# UNITED STATES PATENT AND TRADEMARK OFFICE

APPLICATION NO.	FILING DATE	FIRST NAMED INVENTOR	ATTORNEY DOCKET NO.	CONFIRMATION NO.
10/527,213	11/16/2005	David William Manley	4623-050766	2312

<b>Office Action Summary</b>	<b>Application No.</b> 10/527,213	<b>Applicant(s)</b> MANLEY, DAVID WILLIAM	
	<b>Examiner</b> ROBIN HYLTON	<b>Art Unit</b> 3781

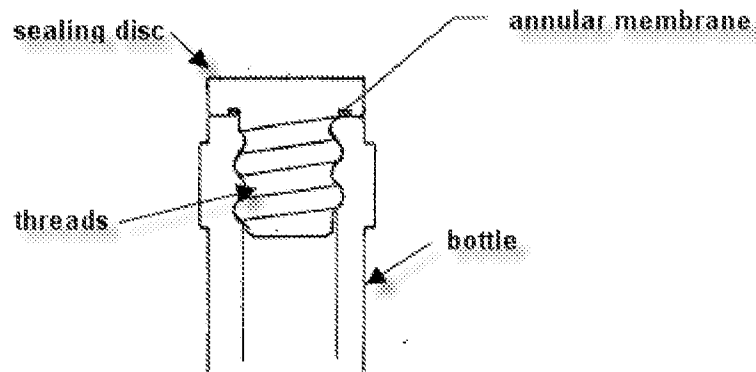
If the sealing disc of claim 29 forms part of the cap, how can the biasing means of claim 34 be between the cap and the sealing disc?

What structure represents the resilient location means engaging an undercut on the container? This structure appears to refer again to the resilient membrane.
